Docket Item # 4
BAR CASE# 2009-0035

BAR Meeting
March 3, 2010

ISSUE: Alterations and Waiver of HVAC Screening

LOCATION: 202 Duke Street

Figure 9: Location of Condenser Units

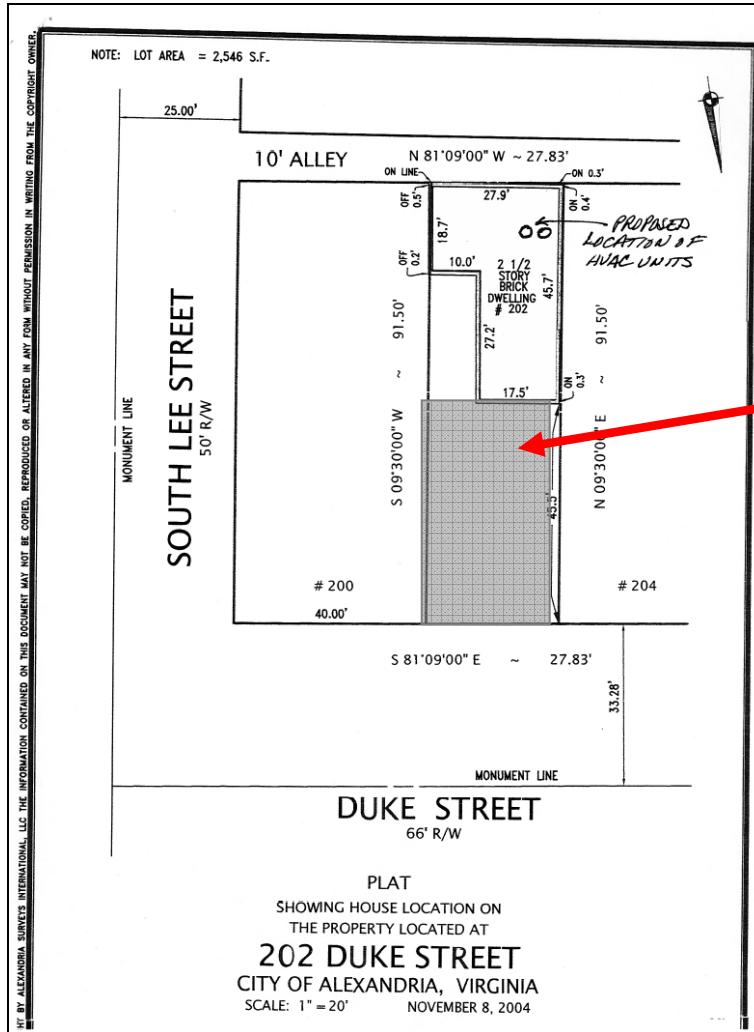
We have reviewed the proposal to locate the air conditioner units on the sloped roof of the addition to the south wall of the main block of the structure and determined that that location does not conflict with the terms of the easement dated December 15, 2004.

The attached plat indicates that the portion of the property covered by the easement lies between the east and west garden walls, from the north wall of the main block of the house to the north wall of the garden. The leg of open space to the east of the flounder is not included in the easement. However, the Commission believes that placing objects such as being considered in that space would adversely affect the quality of the easement because any such objects would detract from views of the overall garden once one makes entry at the gate or stands at most points in the open space covered by the easement.
